3 COMMENTS AND RESPONSES

3.2 PUBLIC AGENCIES AND TRIBAL GOVERNMENTS

DRAFT SUBSEQUENT ENVIRONMENTAL IMPACT REPORT/ENVIRONMENTAL ASSESSMENT (SEIR) FOR RIVERSIDE TRANSMISSION RELIABILITY PROJECT (CALIFORNIA PUBLIC UTILITIES COMMISSION), LOCATED AT THE CITIES OF JURUPA VALLEY, NORCO & RIVERSIDE, RIVERSIDE COUNTY (SCH# 2007011113)

Figure 1 – Alternative 26

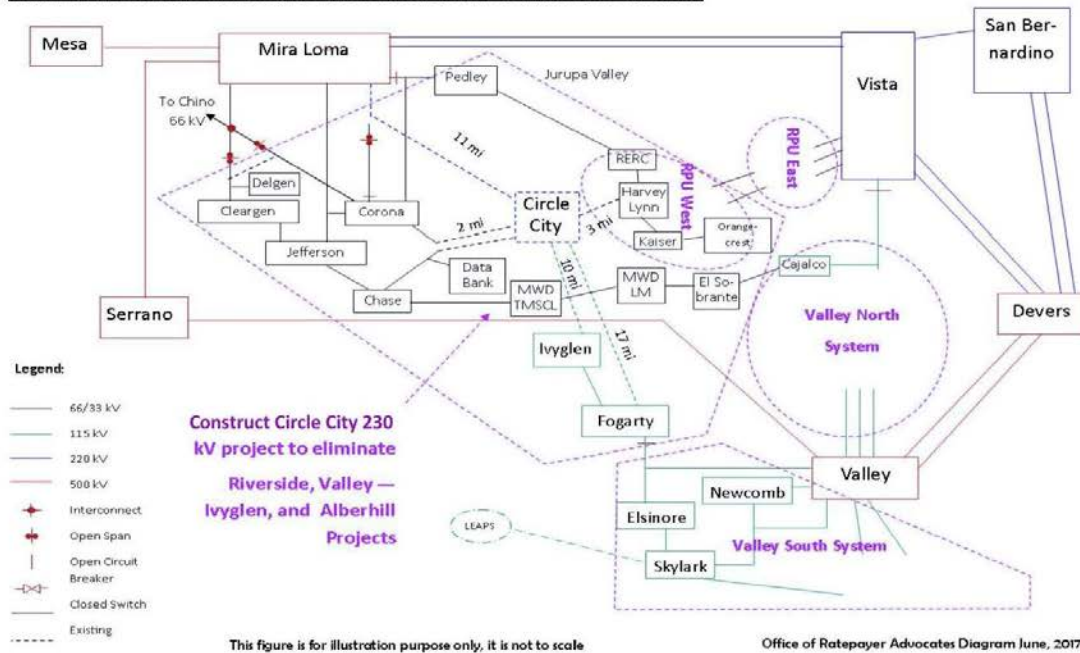
The DSEIR evaluated thirty alternative projects¹ to SCE's Proposed Project,² including ORA's proposed Alternative 26.³ (See Figure 1) Alternative 26 involves modifying SCE's proposed 66 kiloVolt (kV) Circle City Substation Project and constructing new 115 kV and 230 kV transmission lines to replace a number of SCE projects.⁴ This alternative would construct the Circle City Substation as a 230/115/66 kV Substation, and interconnect it to the Mira Loma Substation in the City of Ontario, with approximately 11 miles of 230 kV lines, using existing and some new rights of way (ROW). Approximately 27 (17+10) miles⁵ of 115 kV line along I-15 freeway would be constructed to connect Ivyglen and Fogarty 115 kV Substations to the new Circle City 230 kV Substation. The Circle City Substation would then supply power to the Corona, Pedley, Data Bank, Chase, Jefferson, Cleargen,

Based on this new information, Alternative 26 should be modified (Modified Alternative 26)⁸ to eliminate the need to construct the 27 mile 115kV transmission line. (See Figure 2) ORA's Modified Alternative 26 would construct the Circle City Substation as a 230/66 kV Substation instead of constructing SCE's proposed 66 kV Substation. The Circle City Substation would interconnect to the Mira Loma Substation, which is in the City of Ontario, with approximately 11 miles of 230 kV transmission lines. Then the Circle City Substation would connect to Riverside with a 66 kV transmission lines to serve the RPU's load.

ORA's proposed Modified Alternative 26 meets all of SCE's proposed project objectives, and also would result in less cost and less environmental impact by eliminating the construction of two substations: SCE's Proposed 230 kV Wildlife Substation in the City of Riverside and the RPU's 66 kV Wilderness Substation in the RPU service area. Therefore, the Modified Alternative 26 should be compared to the DSEIR's Alternatives 1 – 4 in the FSEIR.

A3-1 The Office of Ratepayer Advocates (ORA) suggests that in the event that the CPUC adopts the April 4, 2018 Proposed Decision for Valley–Ivyglen and Alberhill, the 27 miles of 115-kV transmission line required by Alternative 26 to connect the Ivyglen and Fogarty substations would be unnecessary (as of the time of writing, the Commission has yet to adopt this proposed decision). ORA further contends that removal of the 115-kV transmission line from the alternative would substantially reduce environmental impacts. ORA, therefore, requests that a modified version of Alternative 26 be re-evaluated without the 115-kV transmission line, based on the proposed decision on the Valley–Ivyglen application.

Constructing the 220-kV transmission line required by the modified Alternative 26 would still cause more impact than constructing the approximately 2.5 miles of transmission line required by the Revised Project due to the construction of substantially longer transmission and power lines. Modified Alternative 26 would be eliminated from further analysis in the Subsequent EIR and a full environmental review of modified Alternative 26 and a comparison to alternatives screened in the Subsequent EIR, therefore, is not necessary.

Figure 2 – Modified Alternative 26

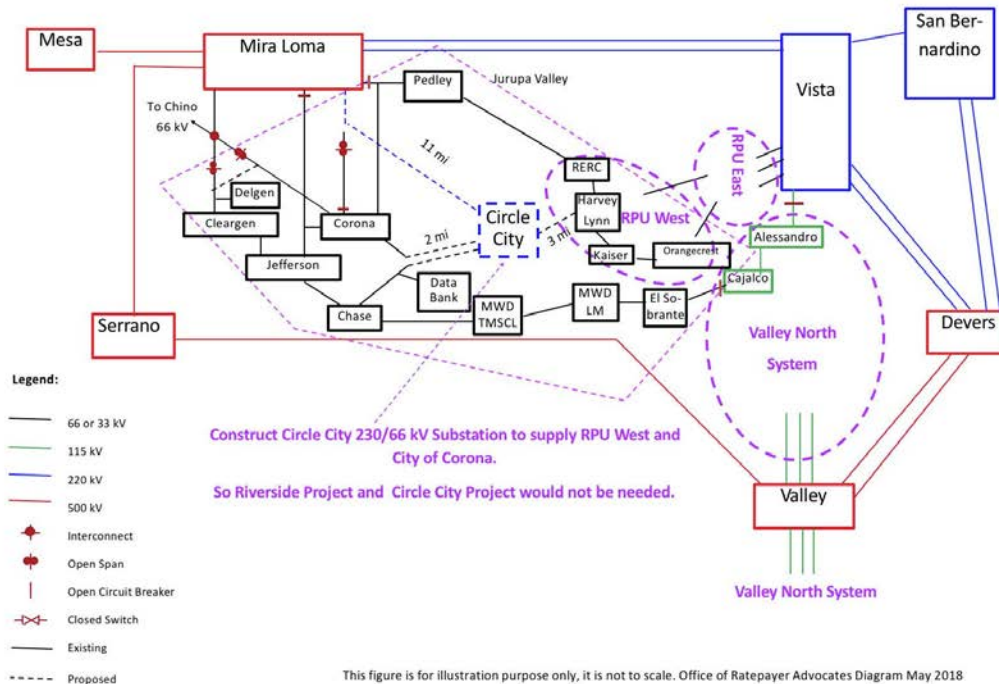
ORA recommends that Modified Alternative 26 be evaluated in the Final Subsequent Environmental Impact Report (FSEIR) to consider the potential approval of Valley-Ivyglen Substation. Modified Alternative 26 meets the basic project objectives, meets the regulatory feasibility criteria, and reduces environmental impacts as discussed below. In addition, ORA recommends the Commission evaluate another bulk transmission alternative (Proposed Bulk Transmission Alternative, see Figure 3) in the FSEIR as discussed below.

The Modified Alternative 26's 230 kV high voltage line route should not have any permitting limitations. In fact, the line route may have fewer environmental impacts compared to the proposed project. For example, there is no need to build two substations (one for the SCE's 230 kV line and one for the RPU's 66 kV lines). Also, construction of the Modified Alternative 26, may not impact lands with legal protection along the transmission route. In addition, the Modified Alternative 26 is consistent with regulatory standards and uses the same technology as the DSEIR's Alternatives 1-4. In fact, a major part of the Modified Alternative 26's 230 kV lines follow SCE's proposed 230 kV Substation siting and routing,

which is in SCE's existing ROW, thus eliminating the acquisition of a major additional ROW. Therefore, the Modified Alternative 26 will improve the feasibility and permitting of a high-voltage transmission line, and reduce the overall cost and environmental impact of the RTRP.

The modified Alternative 26 should more appropriately be compared to the Environmentally Superior Alternative identified in the Circle City Project Draft EIR and the Revised Project.

Figure 3 – Proposed Bulk Transmission Alternative

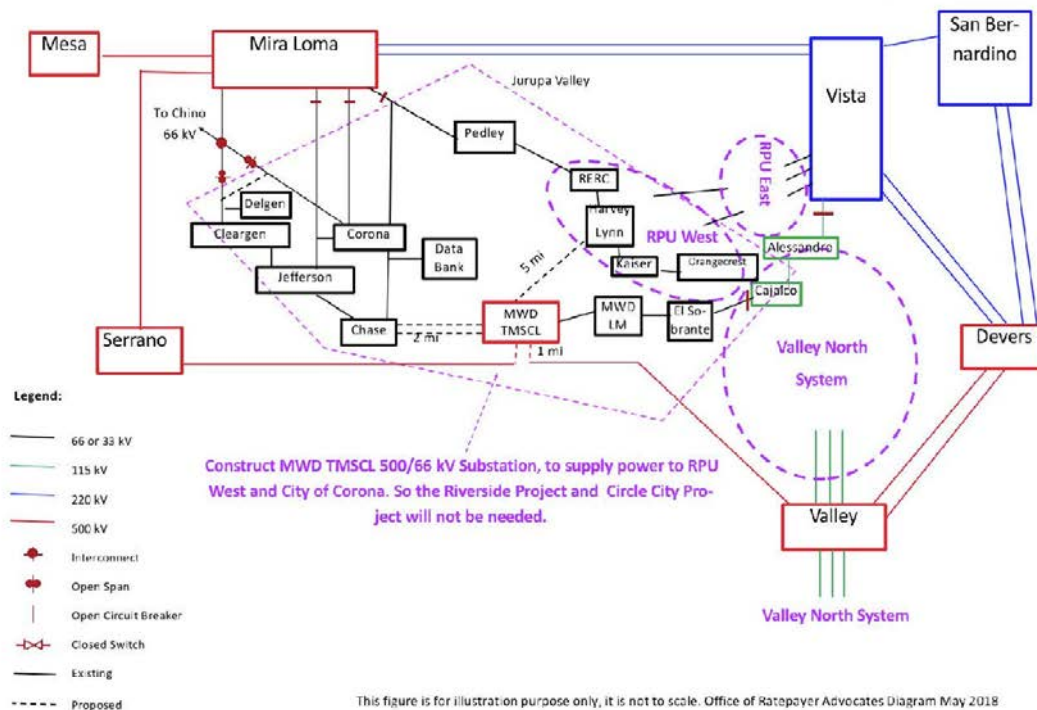
ORA also recommends that the FSEIR evaluate the construction of a new 500 kV Substation to be located at the Metropolitan Water District Substation at Temescal Canyon (MWD-TMSCL). The new 500 kV Substation at MWD-TMSCL would connect to SCE's existing 500 kV Serrano to Valley transmission line and also would connect to RPU's Harvey Lynn 66kV Substation. (See Figure 3) This bulk transmission alternative would: 1) meet all of the project objectives of a bulk transmission resource for SCE and RPU; 2) eliminate the construction of SCE's proposed 230 kV Wildlife Substation and the RPU's 66 kV Wilderness Substation; 3) eliminate all 230 kV underground routings that are recommended in the DSEIR's Alternatives 1–4; 4) cost significantly less than the Proposed Project and Alternatives 1-4; and 5) cause fewer environmental impacts than the Proposed Project. Additionally, this alternative would further reduce the bulk transmission route to about a mile

of 500 kV transmission line to connect with the Serrano/Valley 500 kV transmission line (See Figure 3), while the four alternatives analyzed in the DSEIR and Modified Alternative 26 require 10 – 11 miles of 230 kV transmission lines. In addition to meeting all of the RTRP bulk transmission system objectives, the bulk transmission alternative would cost significantly less and have fewer environmental impacts compared to SCE's Proposed Project and Alternatives 1-4. Therefore, the Commission should conduct a full environmental review on this alternative in the FSEIR and compare it to the four screened alternatives and Modified Alternative 26.

ORA recommends that the Commission conduct full environmental reviews of ORA's Proposed Modified Alternative 26 and Proposed Bulk Transmission Alternative.

A3-3 Comment noted. Refer to responses A3-1 and A3-2 for an explanation as to why Modified Alternative 26 and Proposed Bulk Transmission Alternative are not analyzed in the Subsequent EIR.

Figure 1 Revised Project Elements

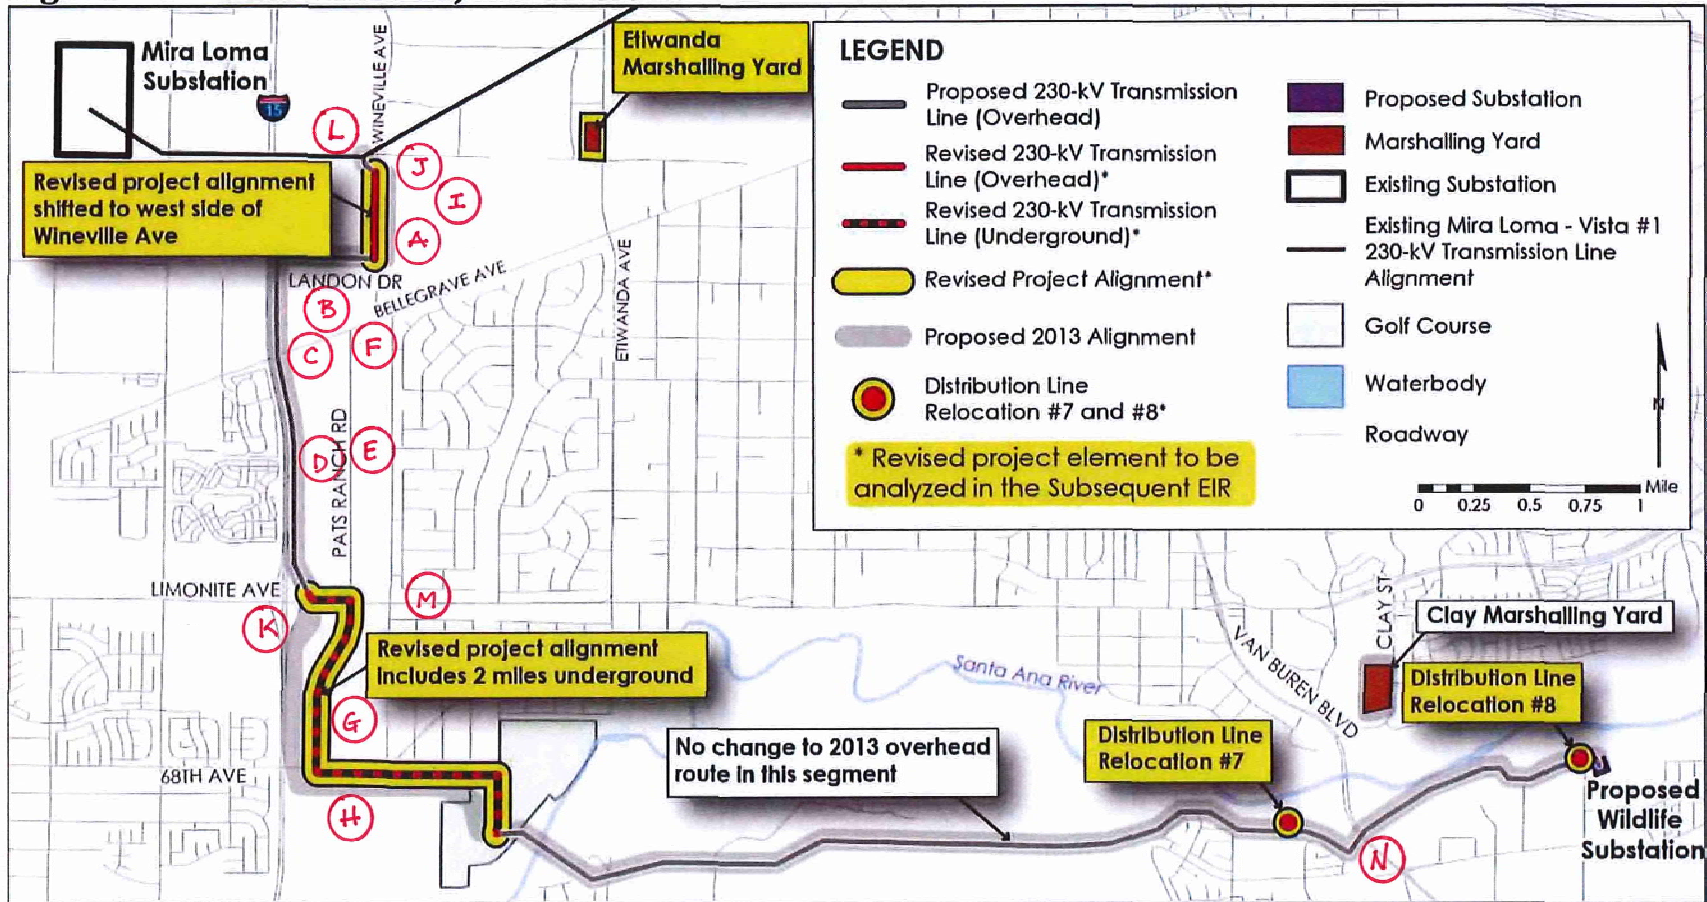
Jurupa Community Services District (JCSD) would like to state its opposition to the route segments of the Riverside Transmission Reliability Project (RTRP) currently in the Draft Subsequent Environmental Impact Report (SEIR) phase which conflict with existing or planned critical water and sewer infrastructure.

The proposed RTRP alignment, which encompasses the Hidden Valley Wildlife Area Boundary Change, crosses several existing, current or proposed projects where the proposed RTRP 100-foot overhead right-of-way or underground alignment may encroach upon, or interfere with senior rights and/or incompatible usage; please see attachments provided.

- A12-2 Water and sewer infrastructure identified in the comment attachments (Figure 1 and in the table included in Comment A12) are included in Table 4.11-2: Known Utilities in the Revised Project Area (Overhead 230-kV Transmission Line) and Table 4.7-4: Known Utilities Near Alternatives 1 through 4. Information obtained from follow-up consultation with Jurupa Community Services District in response to the comment letter was also incorporated into Tables 4.11-2 and 4.7-4, as pertinent. Table 4.11-2 and Table 4.7-4 are revised as follows:

Several of the locations identified on the map (i.e., Locations C, D, E, I, J, and K) are recently completed projects, projects under construction, or proposed for construction in the future. Some of these projects do or would have connections to utility mains. These smaller connections are not included in the existing setting because they are either not complete or are smaller connections to subdivisions. The setting is not intended to be a comprehensive list, but rather to provide a general understanding of the sizes and types of utilities in the area. Refer to Chapter 5: Cumulative Impacts of the Subsequent EIR for further information regarding cumulative impacts from the past, present, and probable future projects considered in combination with the baseline conditions, agency projections, and adopted planning documents. Two of the identified projects (i.e.,

Locations F and L) would be constructed in the probable future and were incorporated into the cumulative project list. Table 5.2-1 is revised to include these two additional projects.

Water and sewer infrastructure identified in Figure 1 of the comment attachment and in the table as “No. N” are not included in the impact analysis. The Revised Project components do not extend into the area of Van Buren Boulevard. The CPUC prepared the Initial Study Checklist (Appendix B) to identify changes in baseline conditions in order to define the scope of review for the Subsequent EIR. Components of the Proposed Project that would result in new or increased potentially significant impacts were analyzed in the Subsequent EIR. The infrastructure identified as “No. N” is located along the components of the Proposed Project that are not reanalyzed in the Subsequent EIR. Refer to MR-3 for further information regarding the scope of the Subsequent EIR.
